THE CLEVELAND ELECTRIC ILLUMINATING COMPANY

PY-CEI/NRR-0010 L

Perry Nuclear Power Plant
Bracket Nos. 50-440; 50-441
SER Outstanding Issue No. 9
Pool Dynamic Loads

APPENDIX 3B
CONTAINMENT LOADS

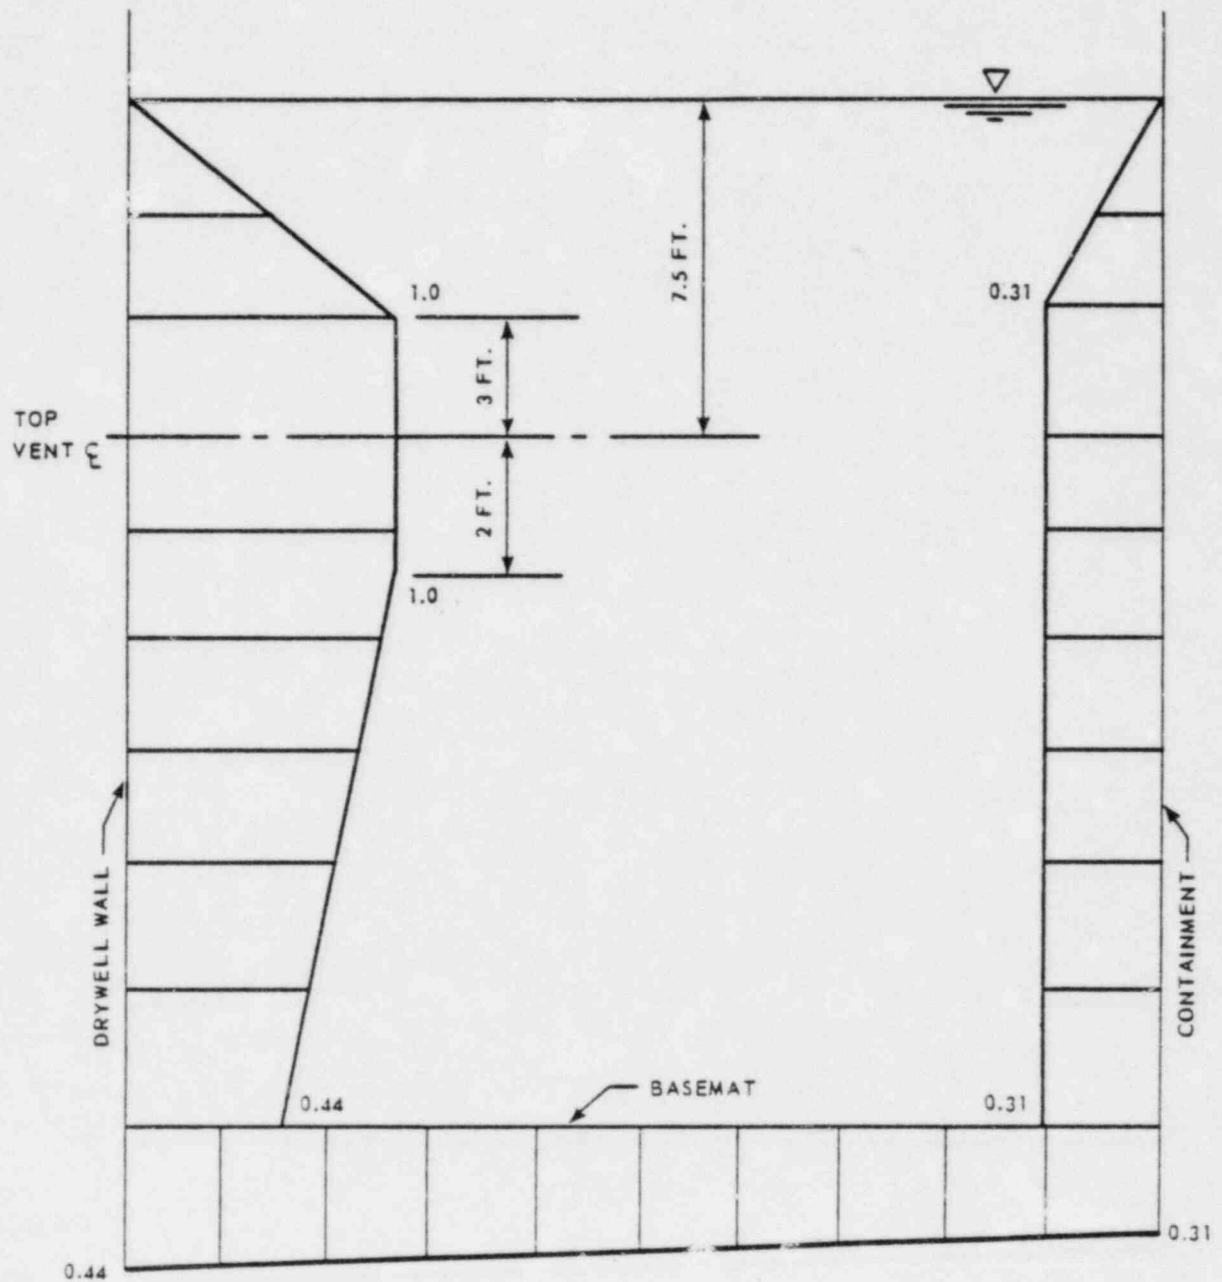
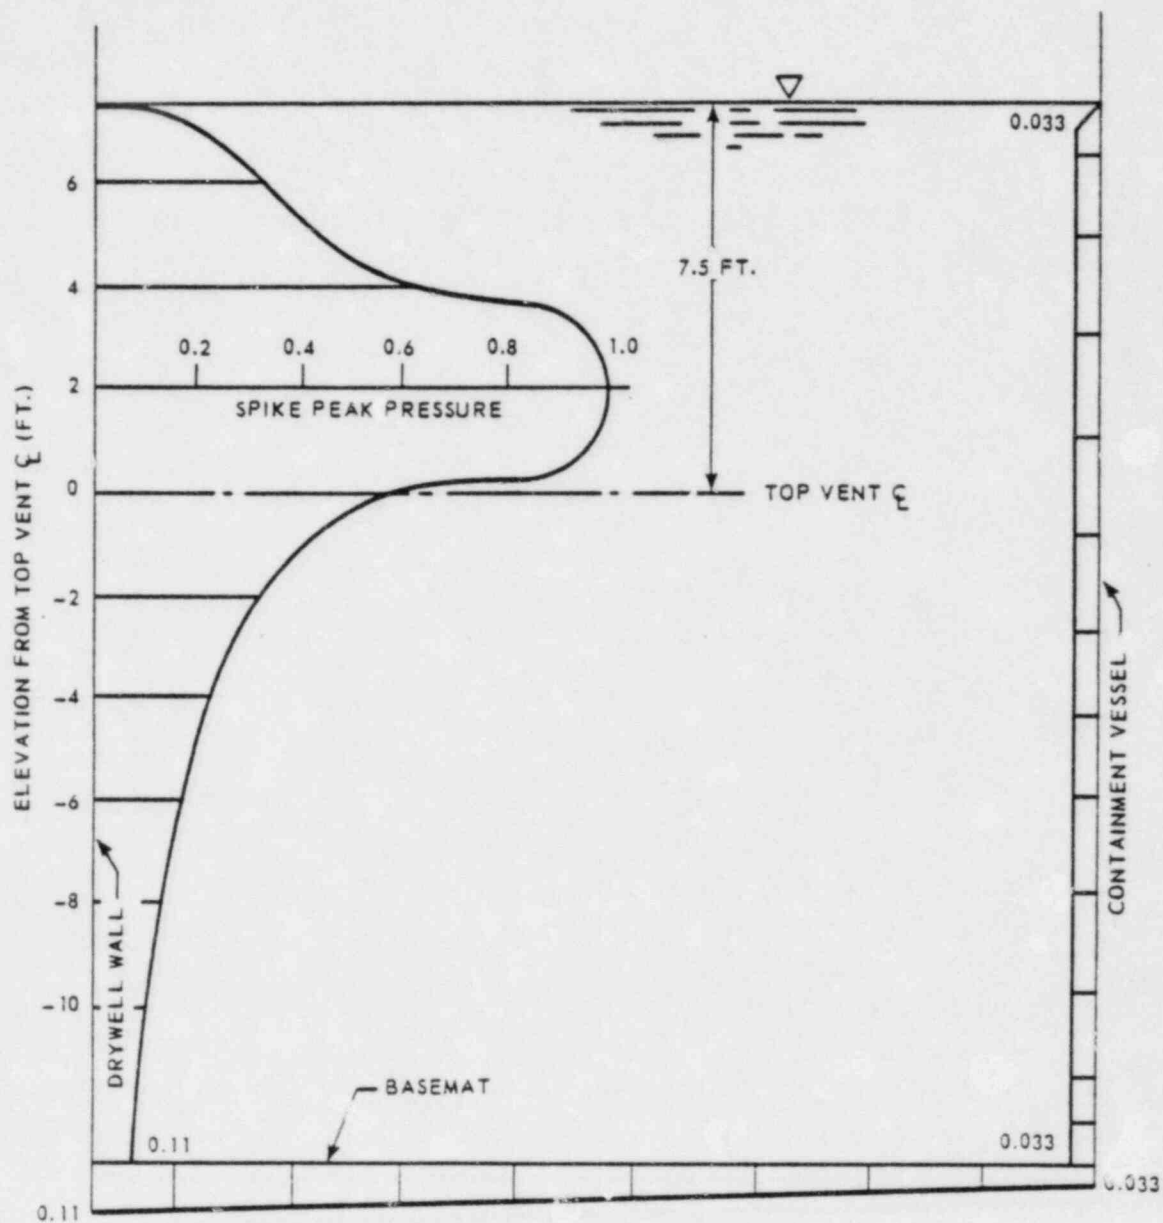
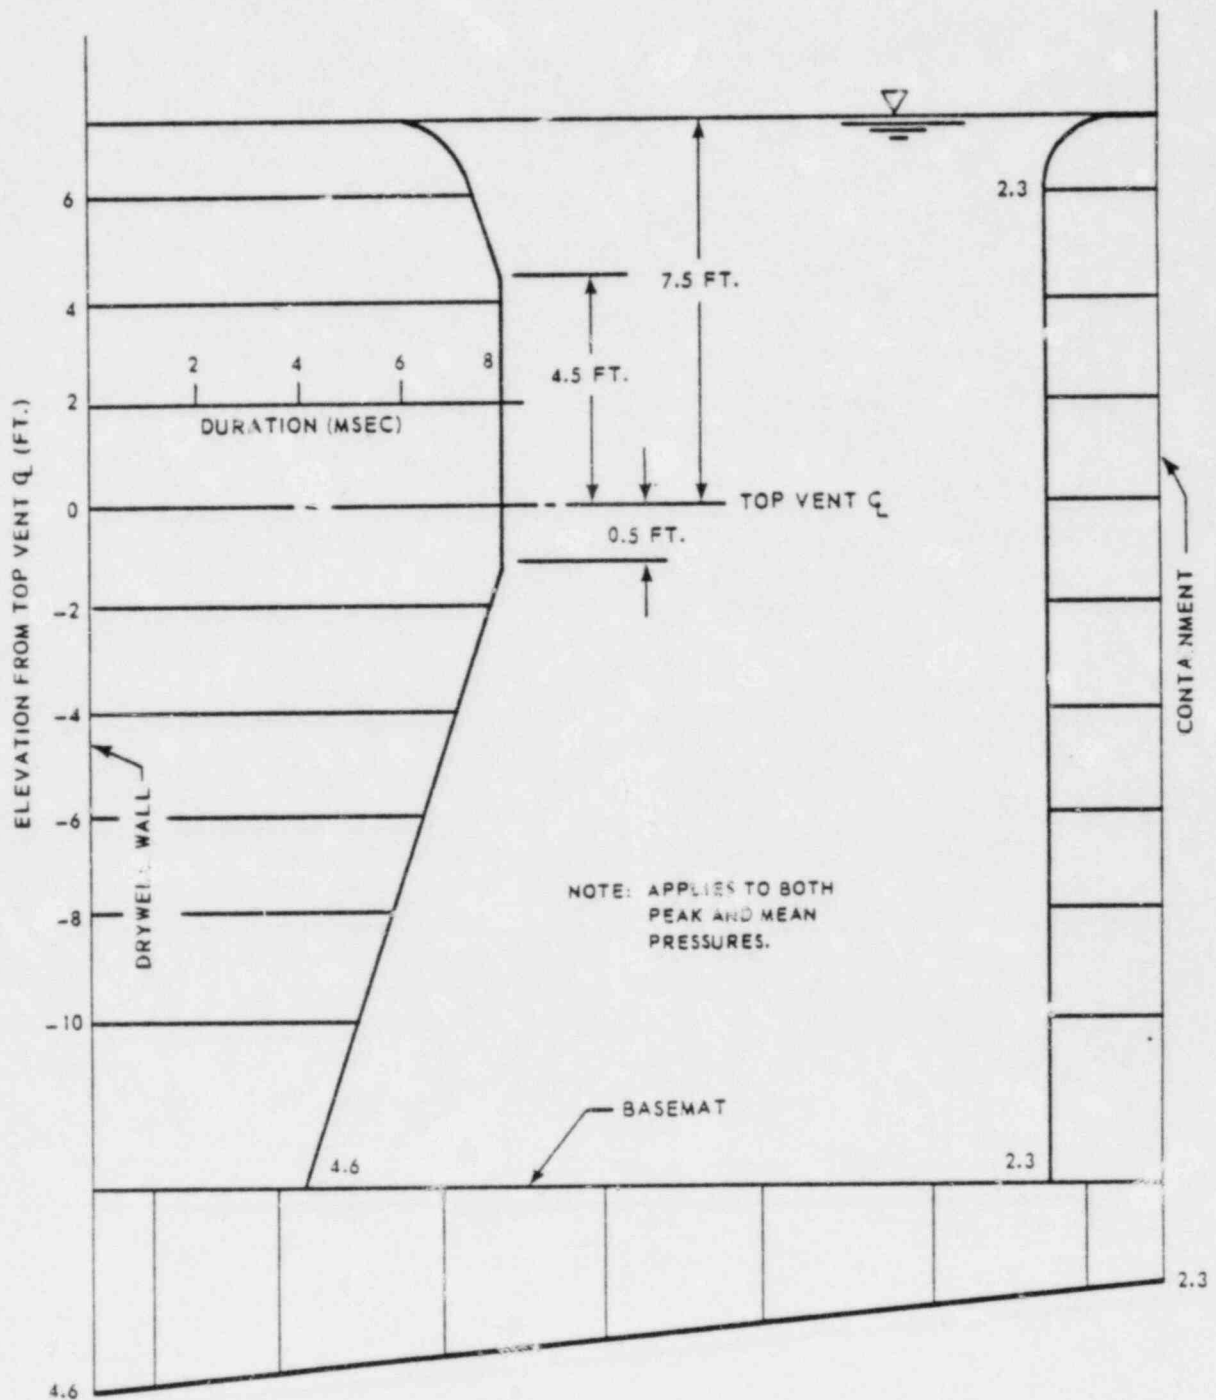
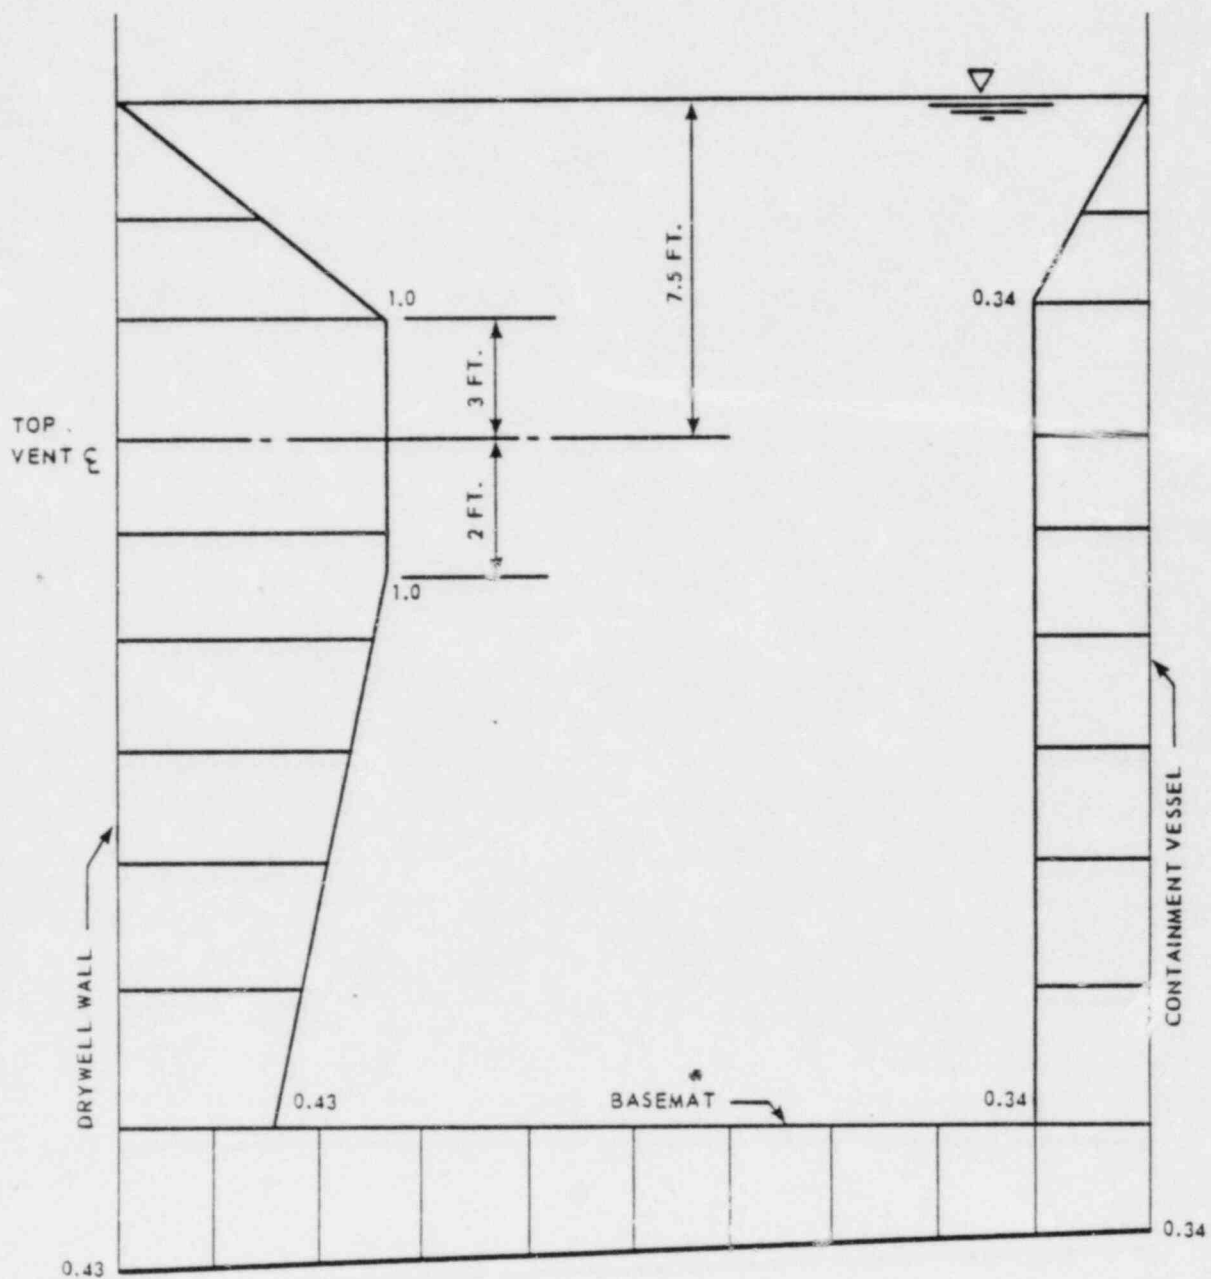
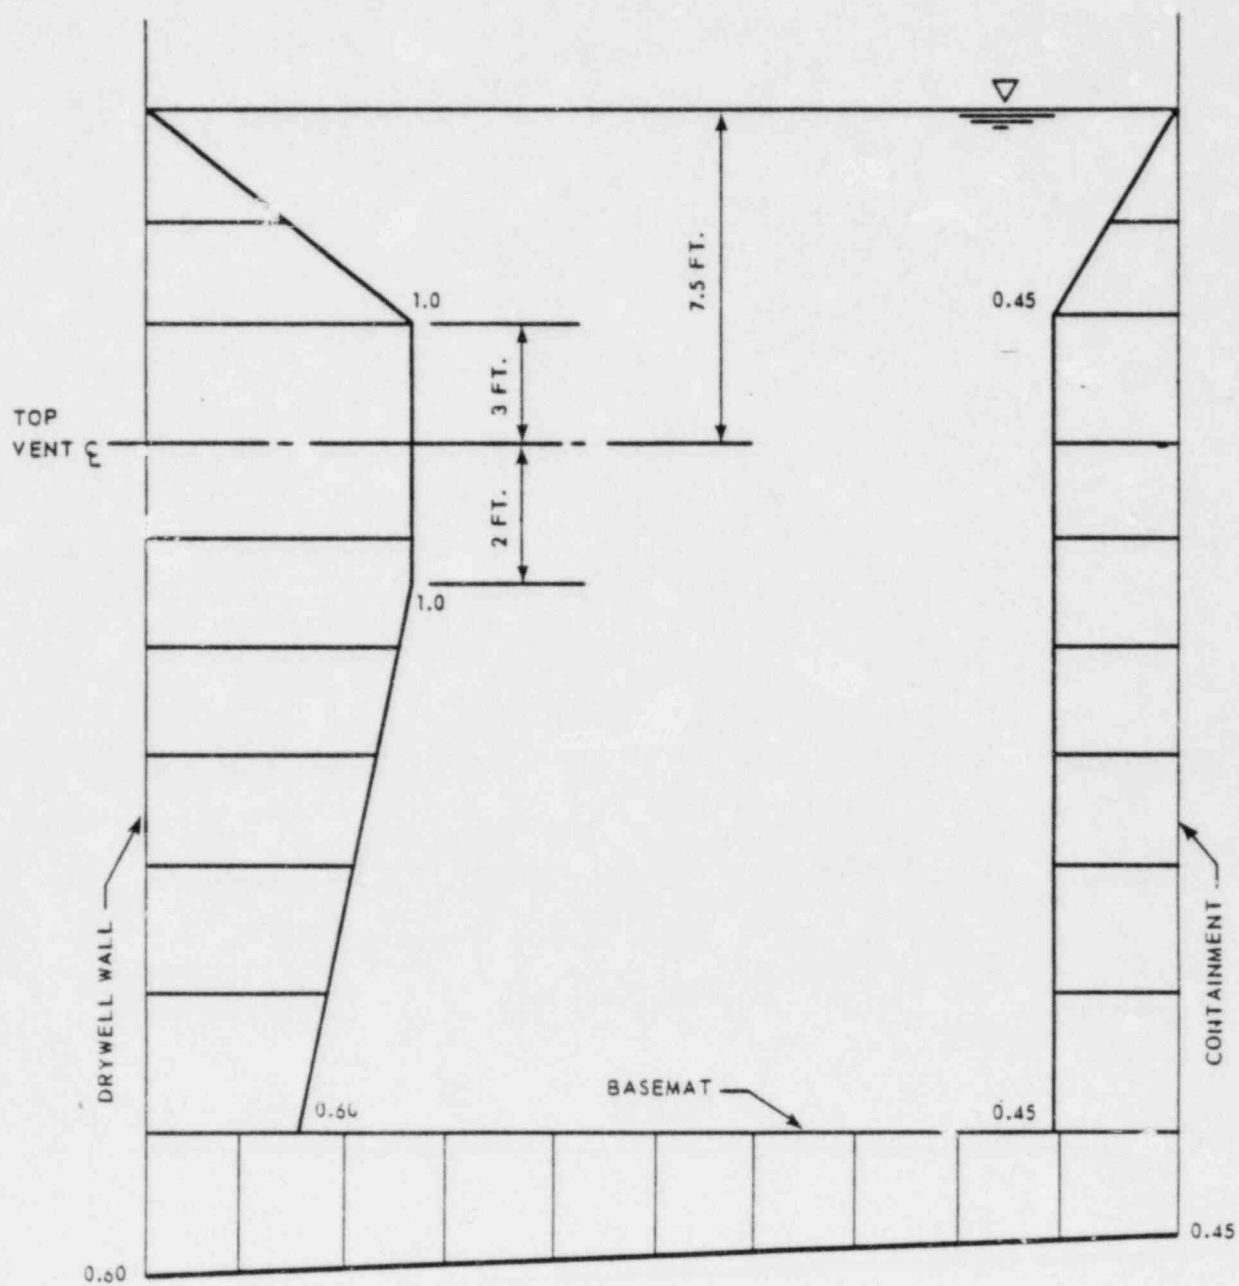
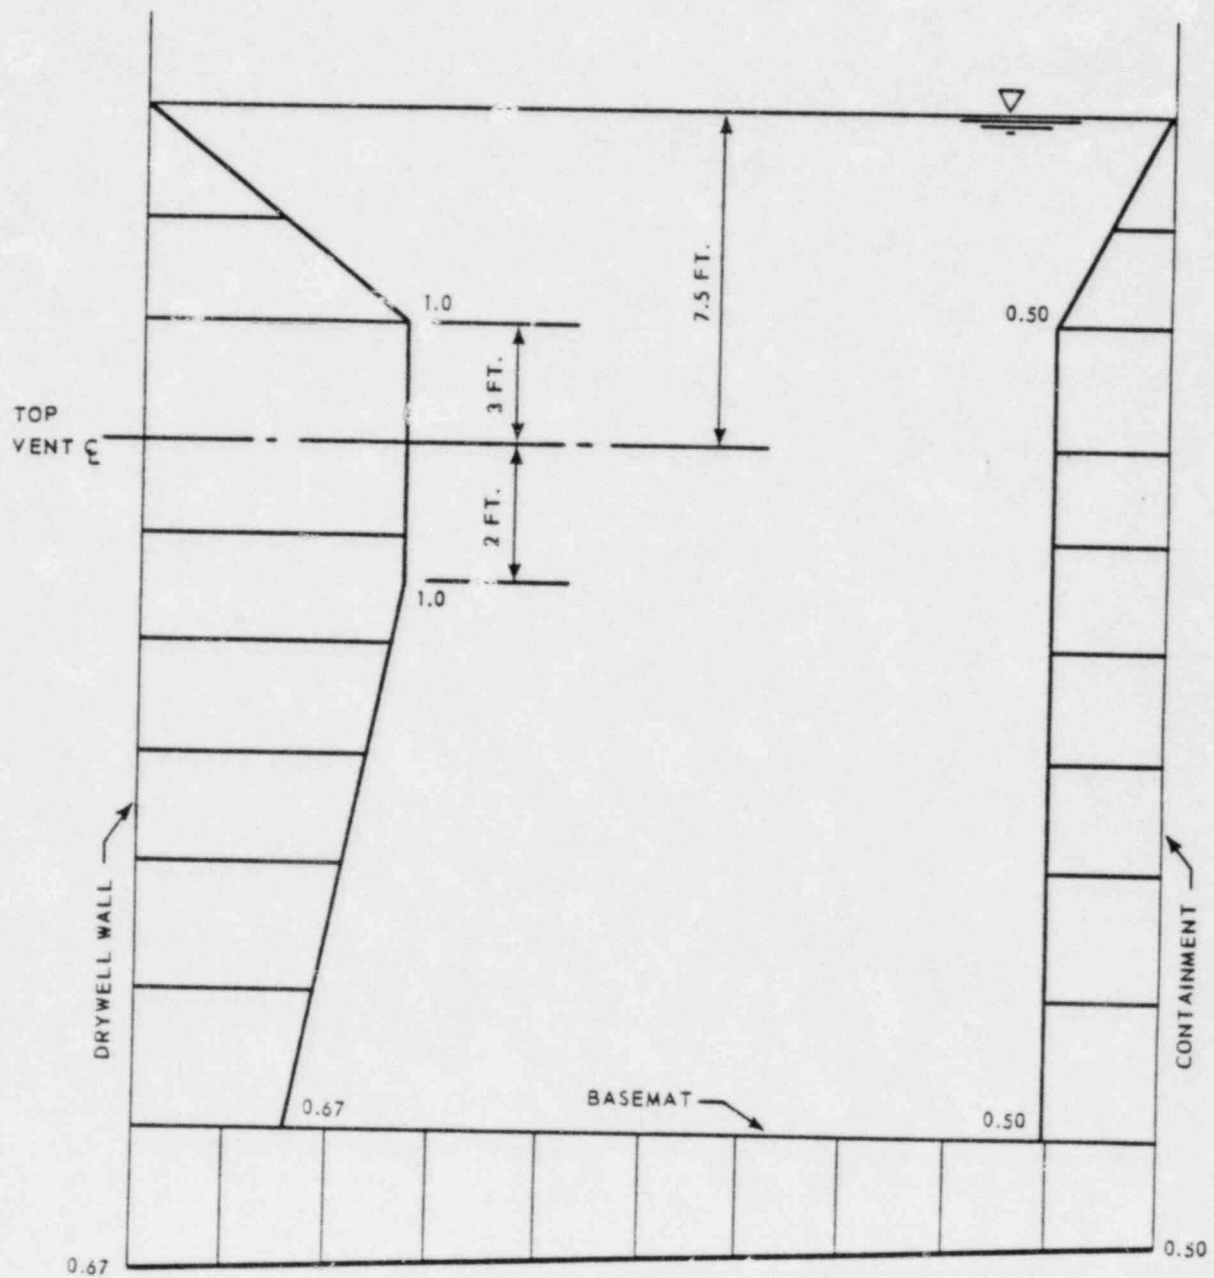
CESSAR Figures 3B-28 through 3B-31, and 3B-34 and 3B-35 are not applicable to Perry. See FSAR Figures 3B-7 through 3B-12.
